RIVERSTONE SOUTH SIXTH ADDITION
 Ramsey, MN

EXISTING CONDITIONS

2 Xcon.pdf V2 - Changemark Notes (1 Note)

3 Preplat.pdf V2 - Changemark Notes (4 Notes)

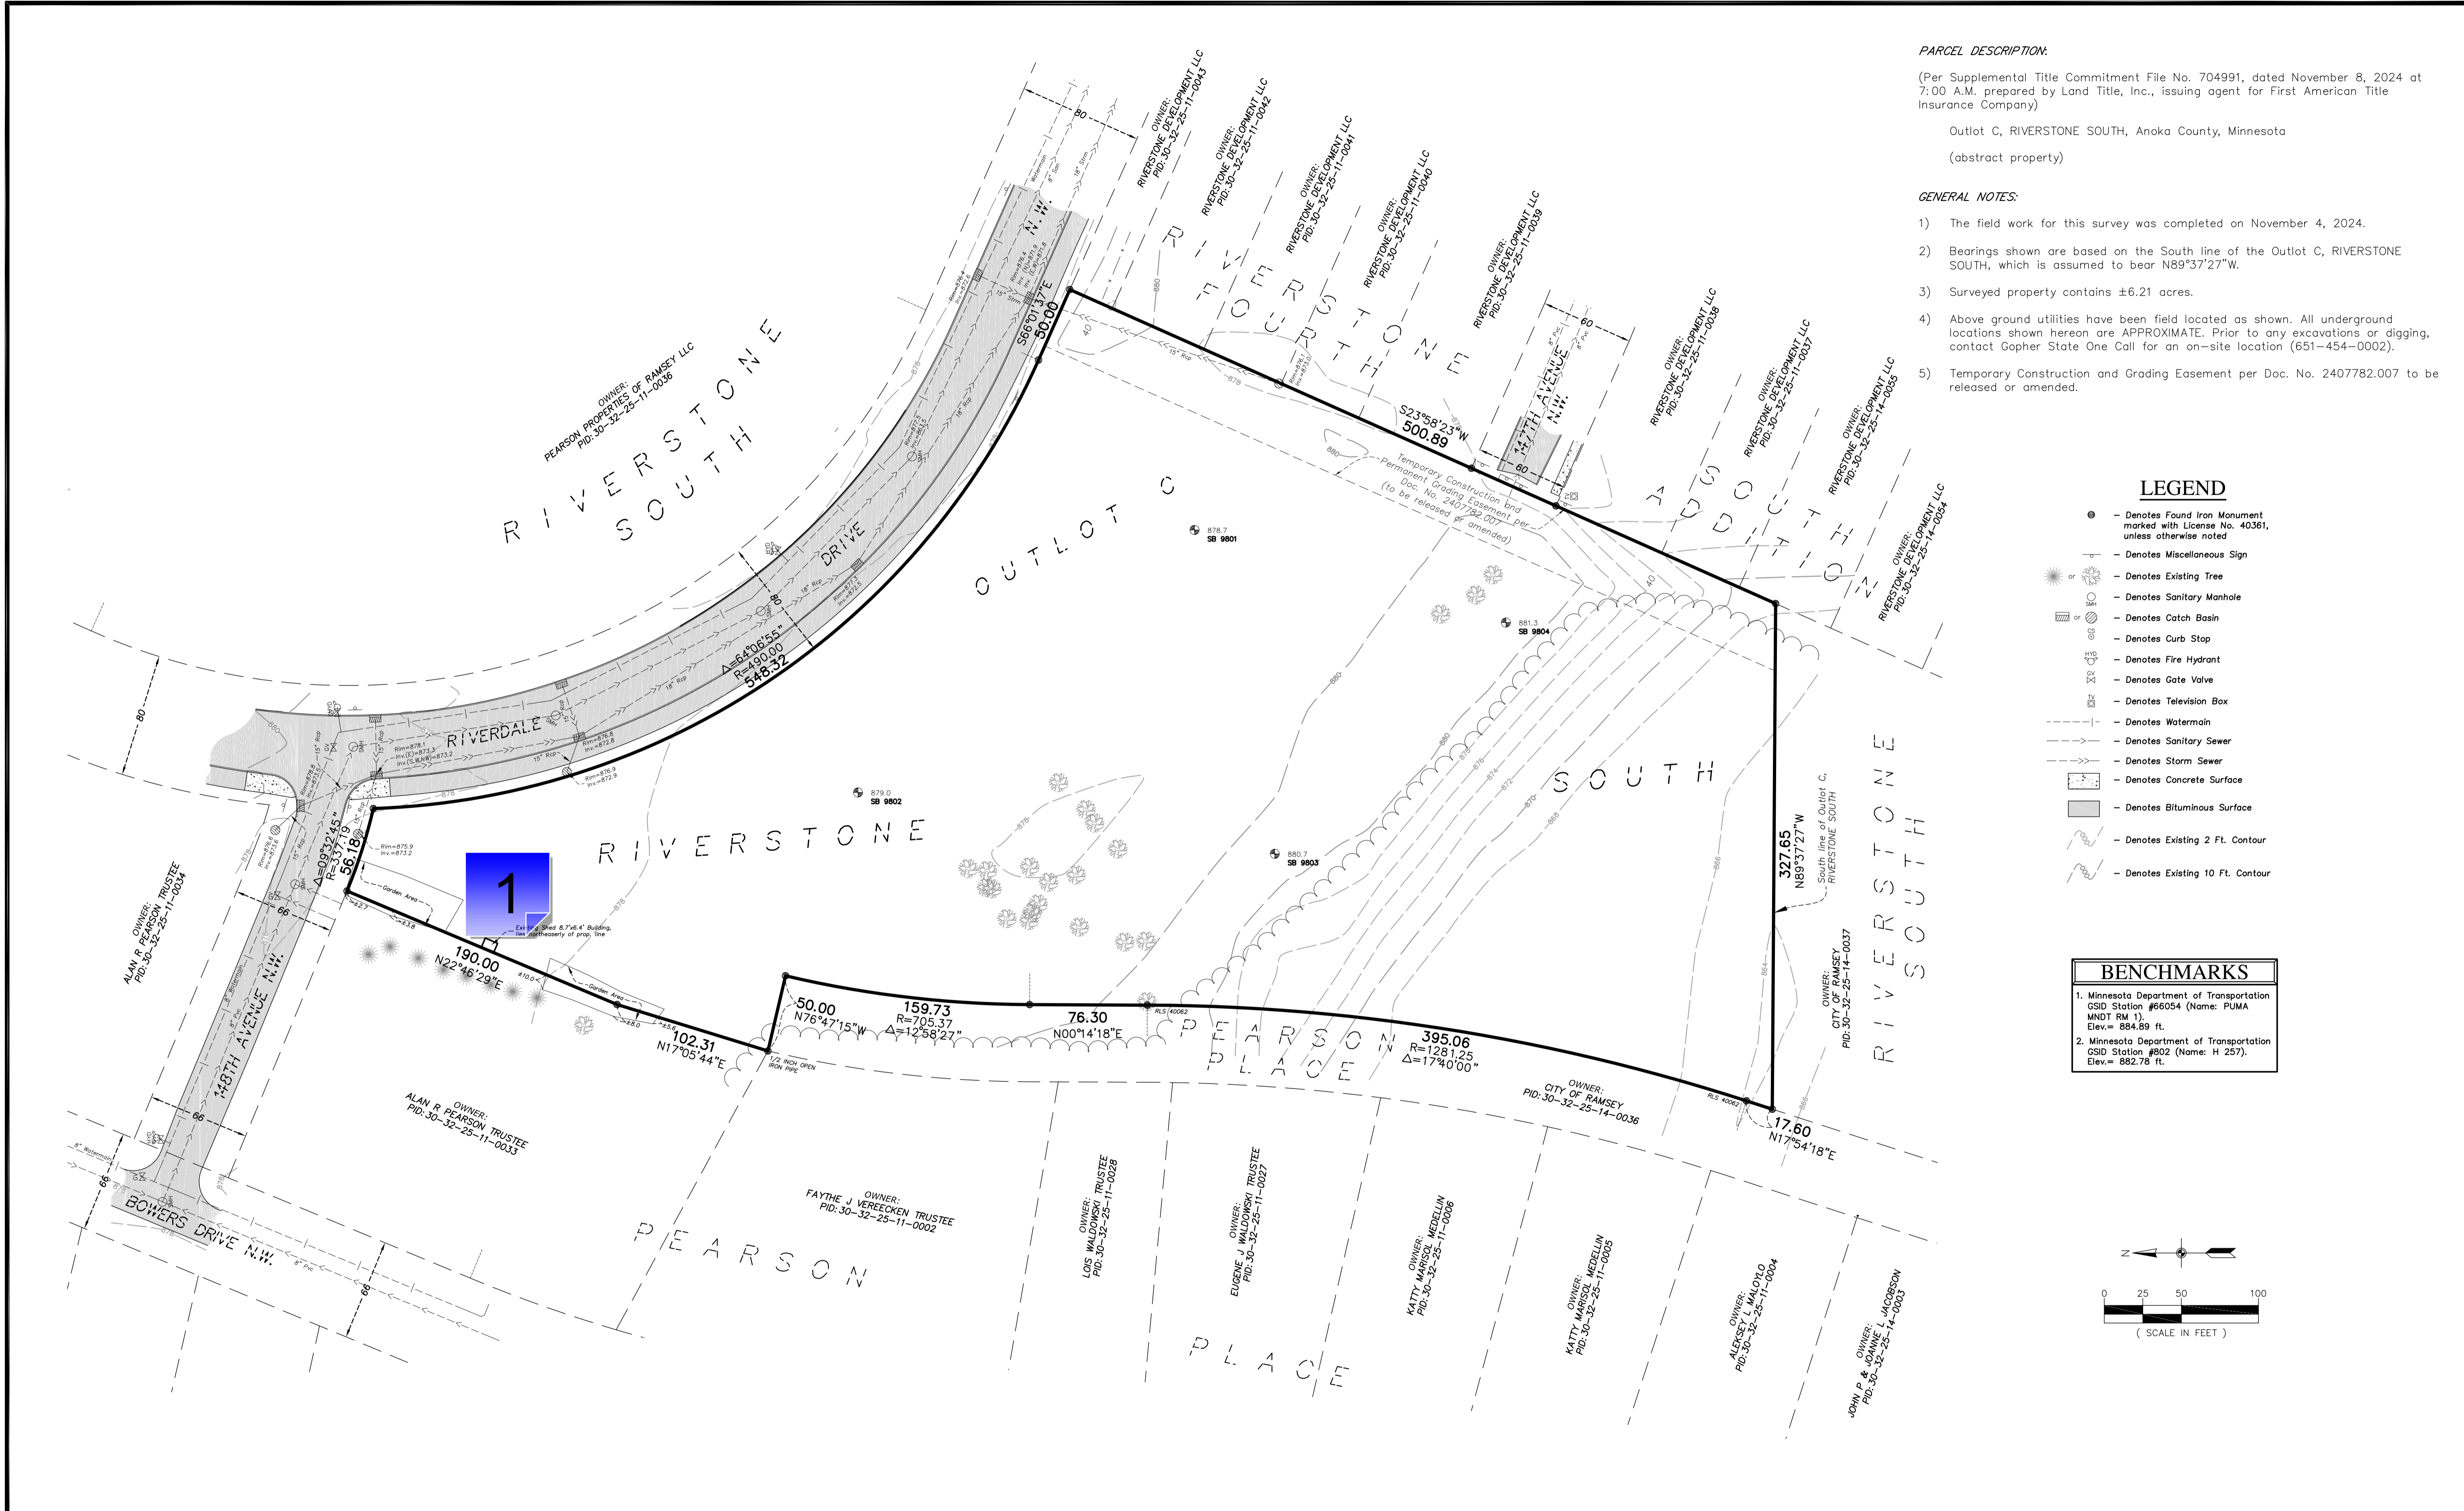
1 - Encroachments

The garden and shed encroachments should be addressed before there are new lots/homes established.

**PRELIMINARY
LANDSCAPE PLAN**

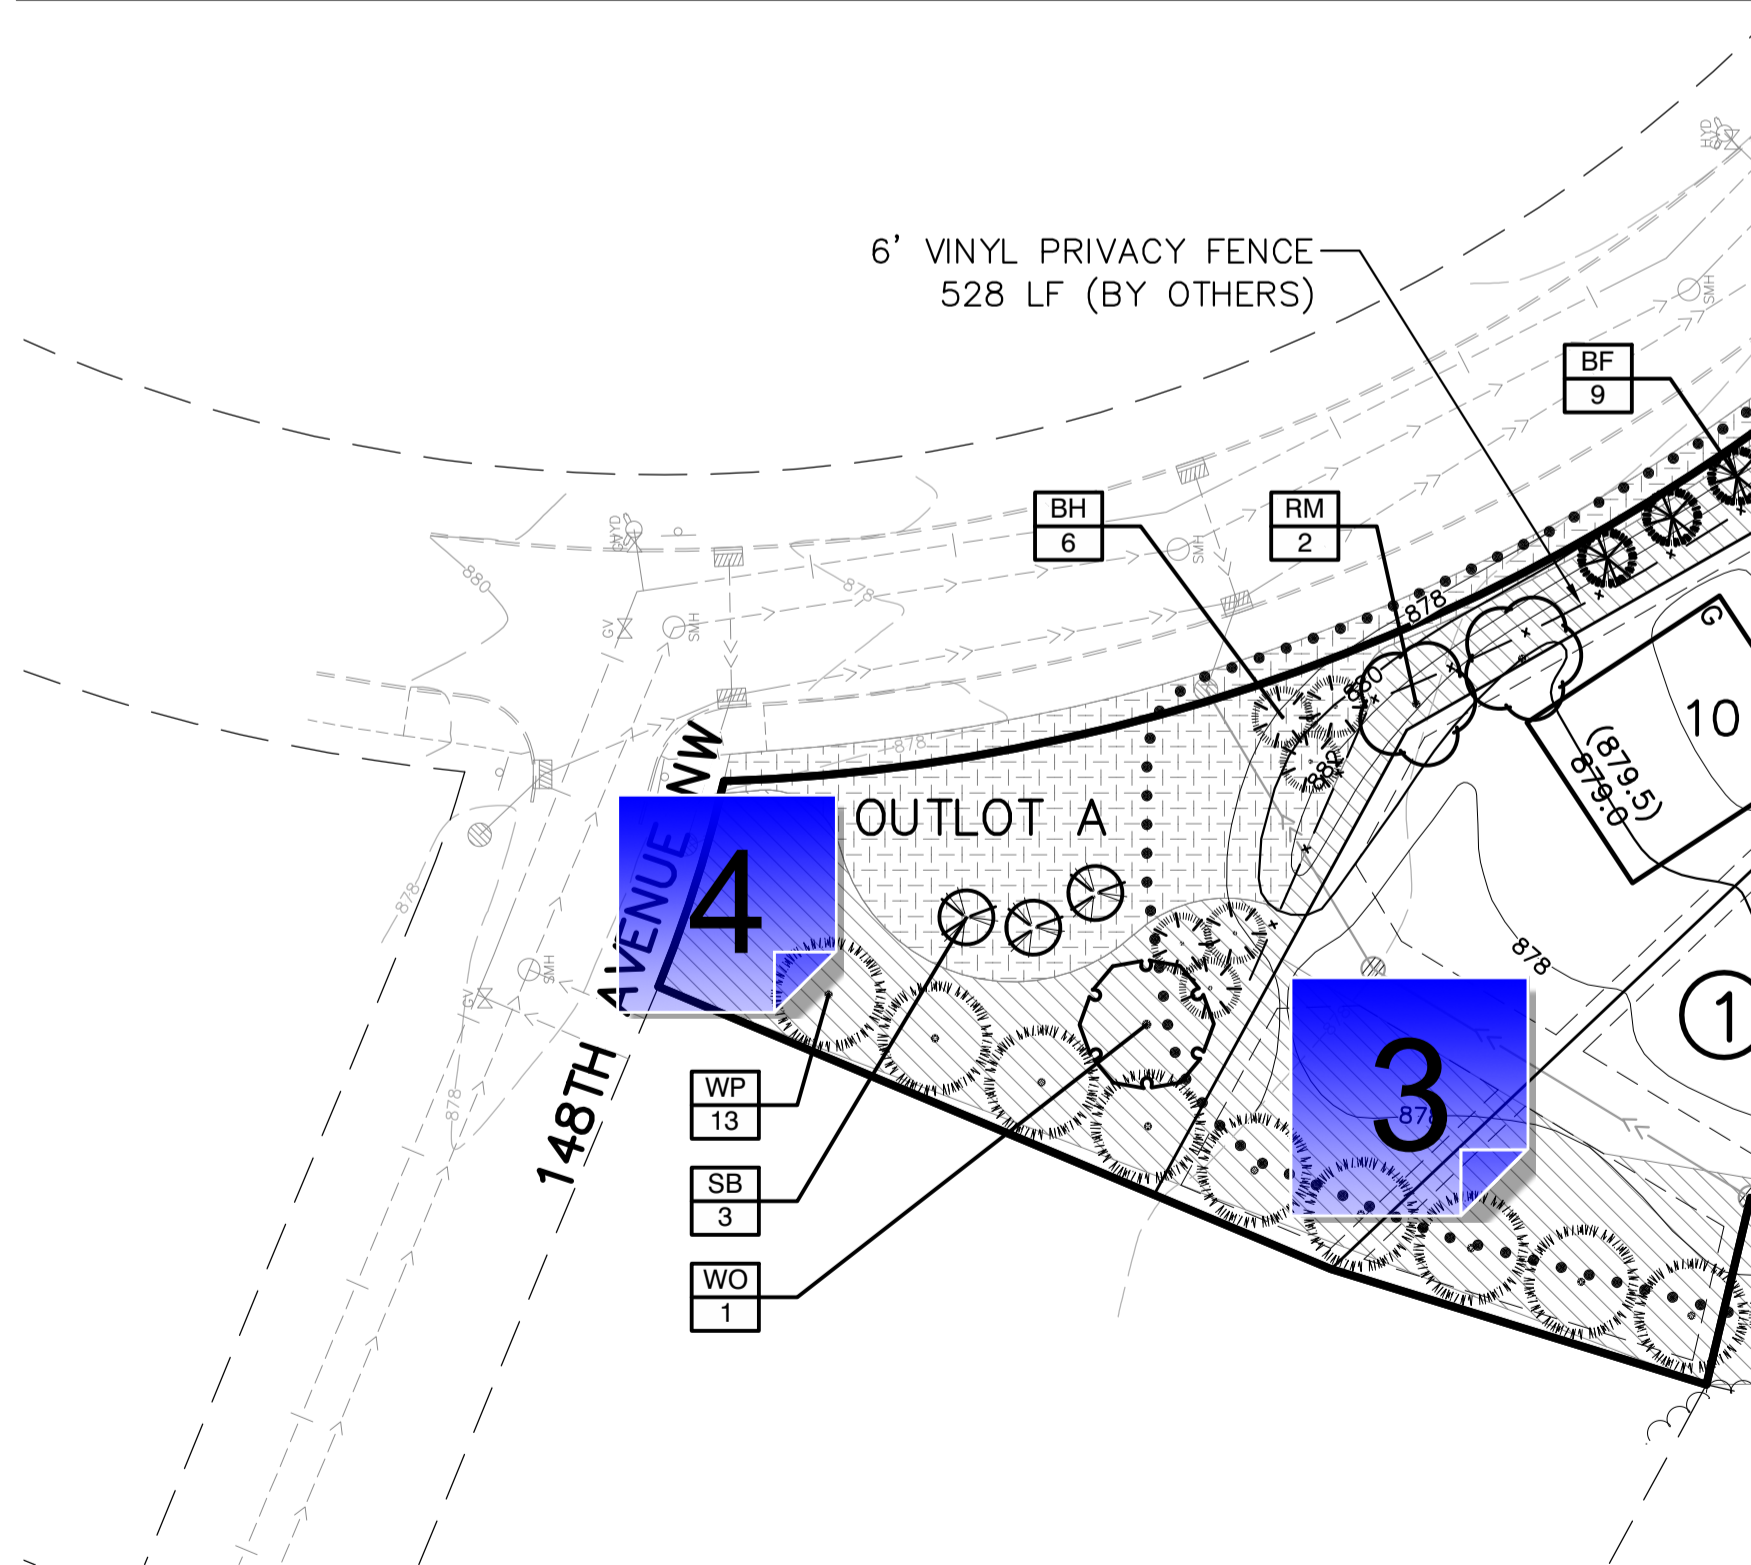
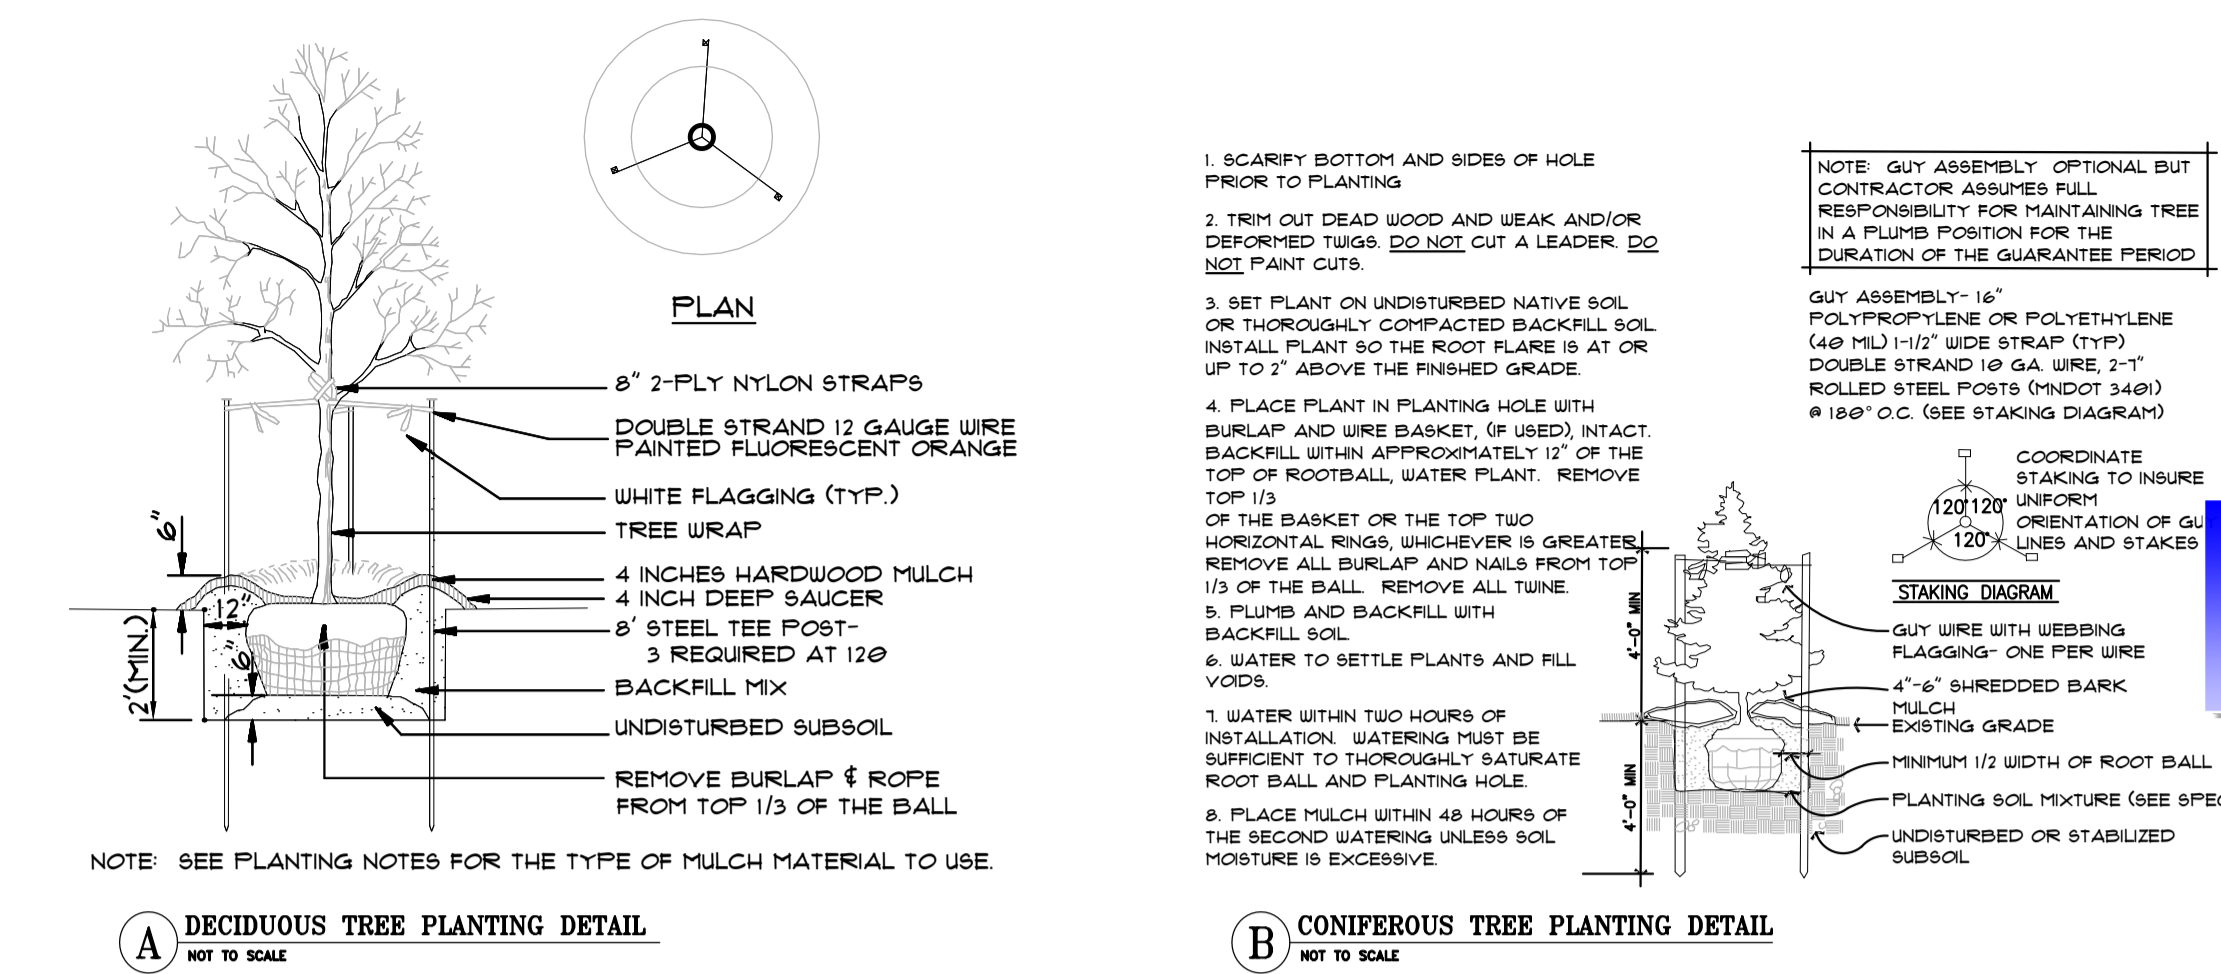
1 - Native Seed Mix

On the streetside of the privacy fence, Staff recommends staying consistent with the established landscape east of here (still part of Riverstone South), meaning it should be established with turf grass rather than a native seed mix.

2 - Move to Boulevard

Could a couple of these backyard trees be moved into the blvd so that spacing of trees along lots 1-4 is more consistent?

Similarly, could one of the backyard trees behind Lots 5 or 6 be moved into the blvd by the common lot line between Lots 5 & 6 to maintain more consistent spacing?

It may make more sense to also modify the species to match the species on either side.

3 - Turf?

I don't think it makes sense to use a native seed mix in the rear yards of Lots 9 and 10. These areas should be sodded like the remainder of the yard will be.

4 - Sod

With the compact nature of this development, use of any alternative type of seed mix is not recommended. We strongly recommend just sodding all of outlot A.

5 - Sufficient Sunlight for this Seed Mix

On the city's 50-foot wide corridor, will there be enough sunlight for this seed mix to establish?

6 - Oak Wilt

Due to oaks being present on site and on the adjacent properties, any clearing involving oaks must be completed prior to April 15 or after July 15 to minimize the chances of introducing oak wilt to the area.

PRELIMINARY PLAT

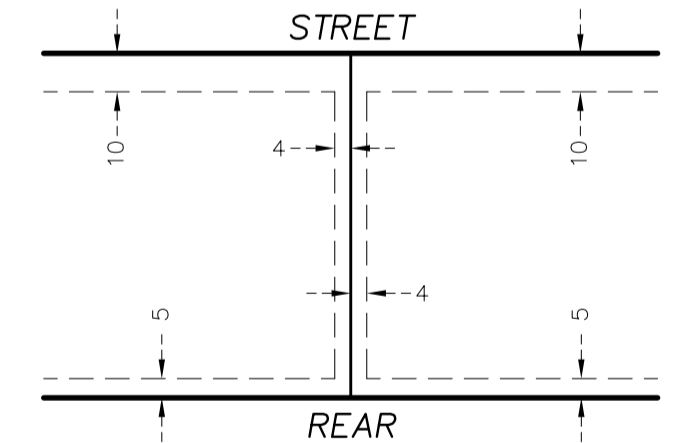
1 - Lot Width Measurement

Please add the lot width, measured at the minimum front yard setback of 25 feet, for Lots 1-10, Block 1. Each lot must be at least 65 feet wide at the minimum required front setback.

Please note that the measurements provided for Lots 3-5 and Lot 9 do not appear to be at the minimum required front setback line (25 feet back from front lot line). The measurement is at about 27 feet for Lots 3-5 and 30-31 feet for Lot 9.

2 - Lot Frontage

With the updated Zoning Code, there is now a minimum lot frontage requirement for all newly created lots. In the R1-B District, the minimum required lot frontage is 45 feet. Lot 9, Block 1 is deficient. Please adjust lot lines accordingly to ensure that all lots not only have 45 feet of frontage along the road but are each also 65 feet wide (measured at the minimum required front setback line).

3 - House Locations

All homes constructed will need to meet the minimum front yard setback of 25 feet and cannot be setback more than 35 feet from the front lot line.

4 - Impervious Coverage

Surveys for each building permit will need to include the total proposed impervious coverage for each lot. Impervious coverage is limited to a maximum of 40%, and since this is within the Mississippi River Corridor Critical Area (MRCCA), it is necessary to verify compliance with this standard.
